Community Development Committee

Business Item: 2024-25 - Amended

City of North Oaks Red Forest Way South Comprehensive Plan Amendment (Amended), Review File 21796-3

Figure 2. Location Map Showing Community Designations

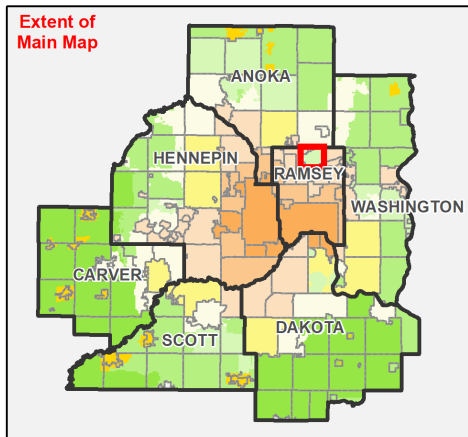
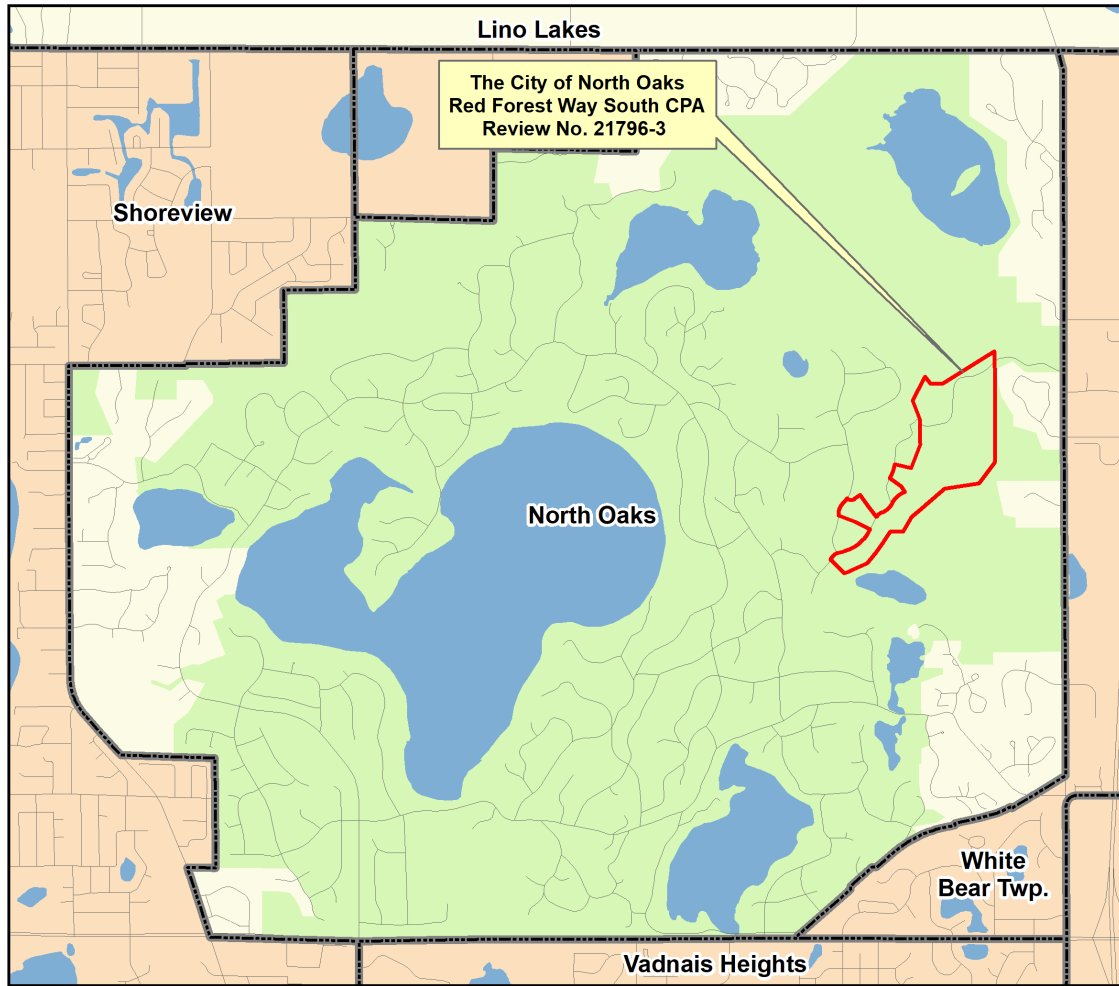
Thrive MSP 2040 (Thrive) identifies the City as an Emerging Suburban Edge Community and as a Rural Residential Community (Figure 2). The area of the City proposed for development is designated as Rural Residential which does not allow for the provision of regional sewer services due to the development patterns or topographical constraints that “do not support the economical extension of wastewater services” (Thrive, p. 108). In order to extend sewer service to this area as proposed in the amendment, the Council would need to agree to change this area from Rural Residential to an Emerging Suburban Edge community designation.

This amendment includes a proposed change to the Community Designation from Rural Residential to Emerging Suburban Edge.

Figure 3. Location Map Showing Metropolitan Urban Service Area (MUSA)

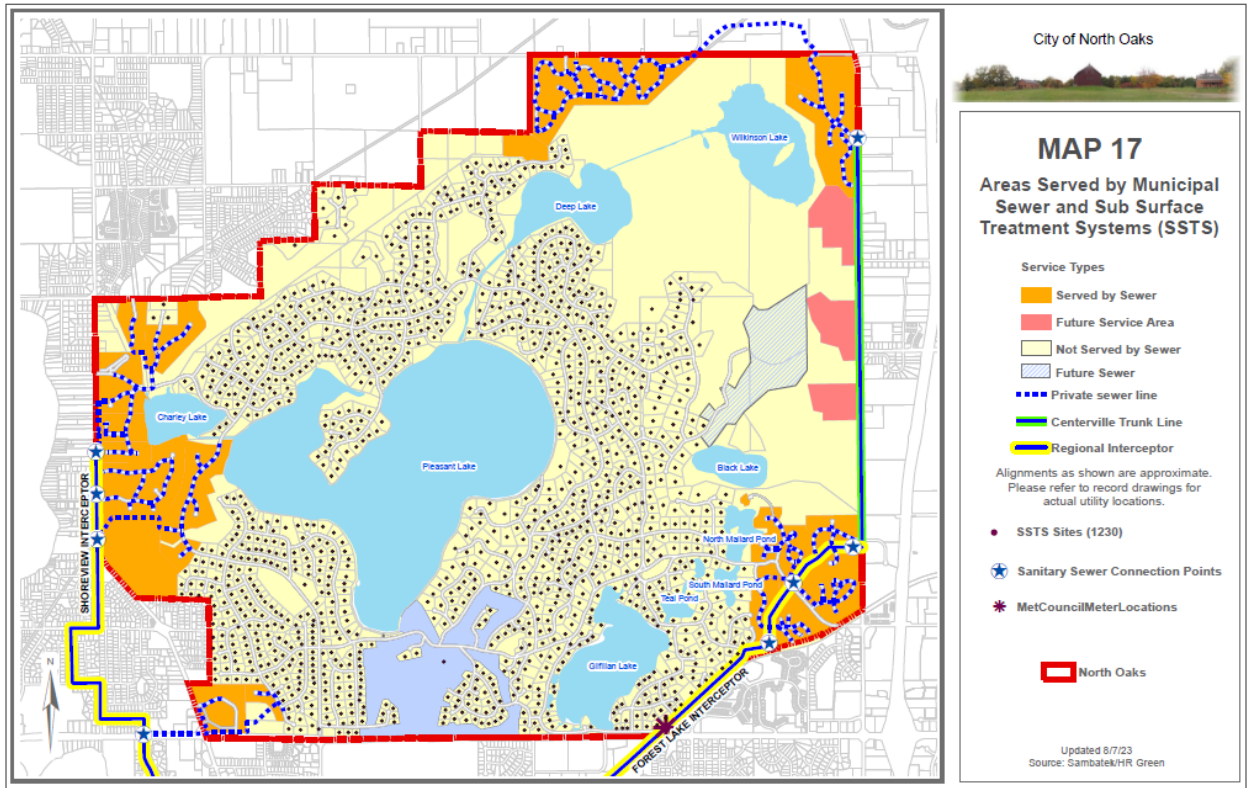
The amendment area (shaded gray) is proposed to be included in the 2030 MUSA.
